## **ZODIAC AEROSPACE SERVICES**

**This Transmittal Sheet applies to the Revision 02, dated 20140625, of Service Bulletin MC10-35-274**

## SERVICE BULLETIN

### TITLE: OXYGEN – HARNESS ASSEMBLY - INSPECTION FOR POTENTIAL DEFECTIVE COMPONENT

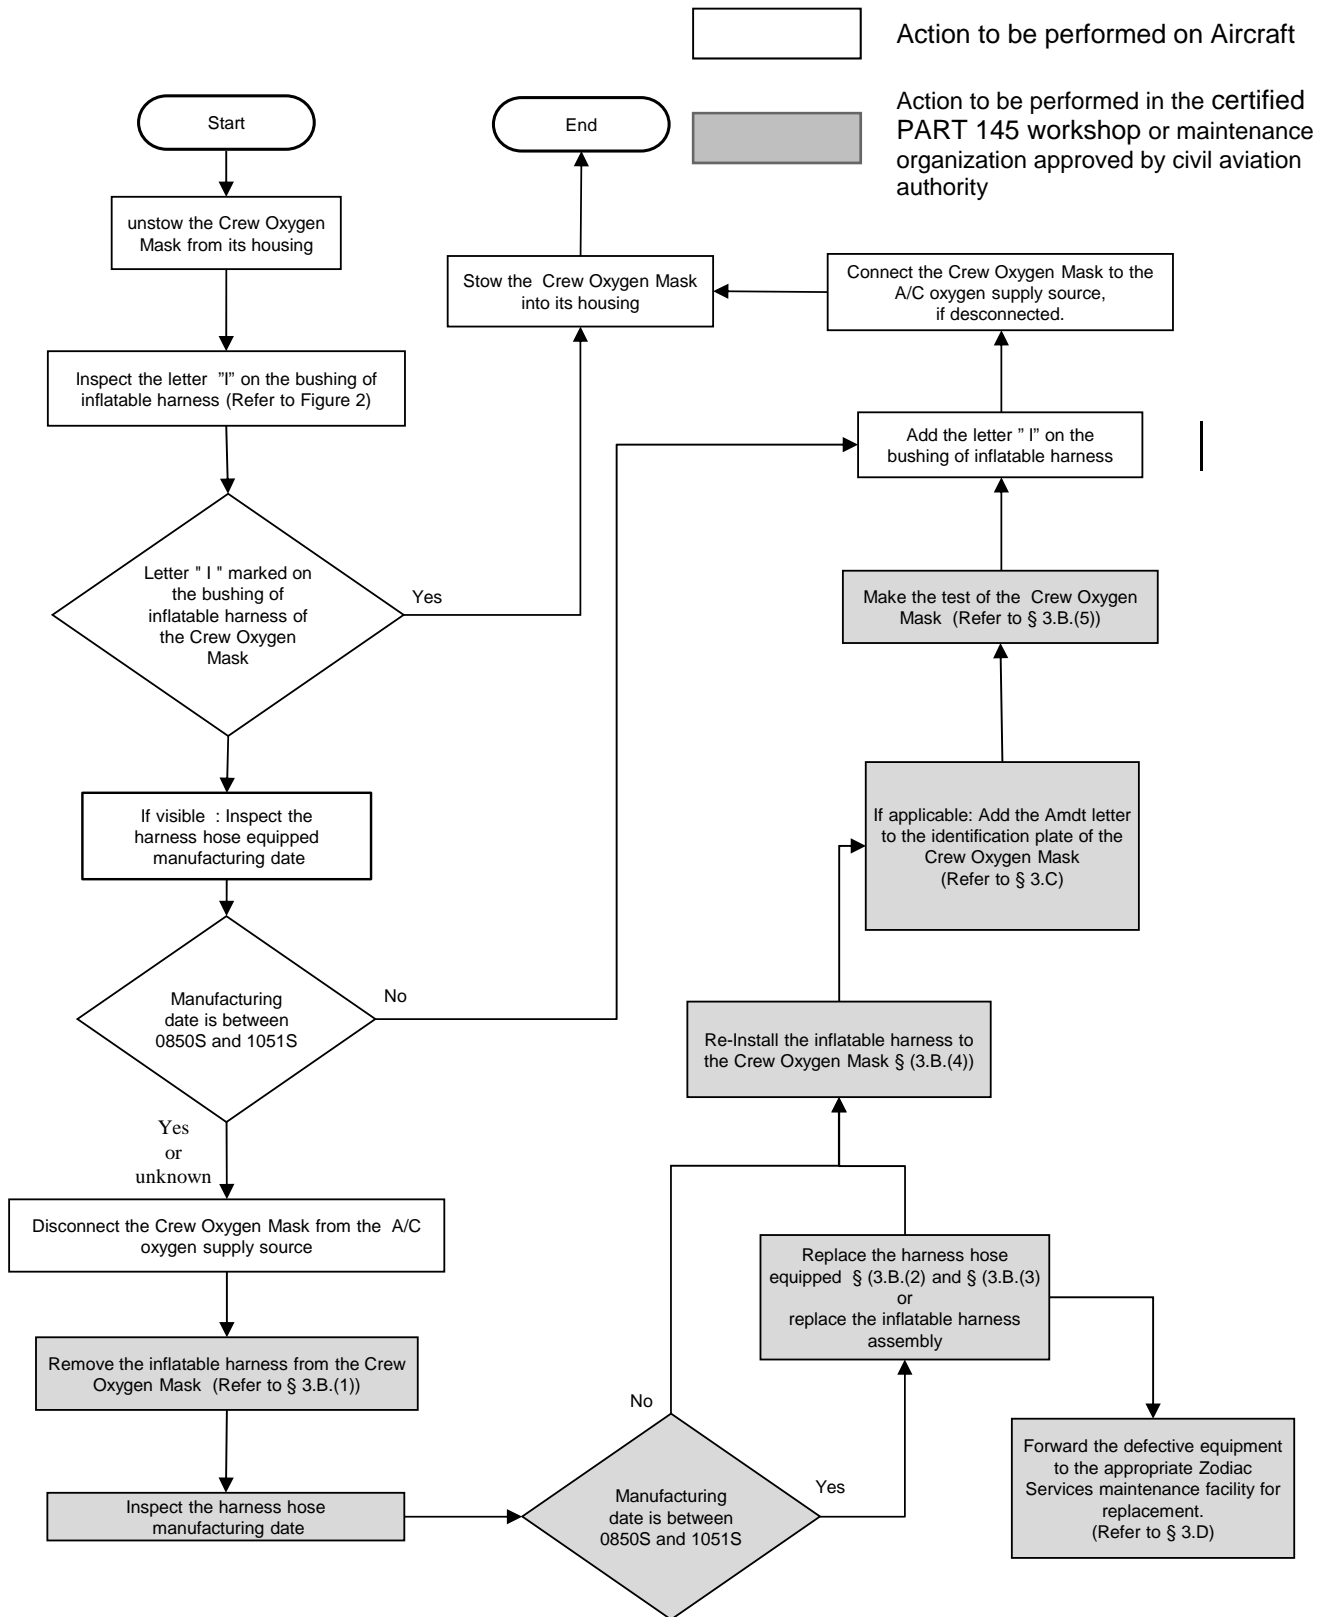
(1) Inspect the manufacturing date (See Figure 3) of the inflatable harness or harness hose equipped :

- If the manufacturing date is in the specified period above, forward the defective inflatable harness or harness hose equipped to the appropriate Zodiac Services maintenance facility for replacement of the inflatable harness.
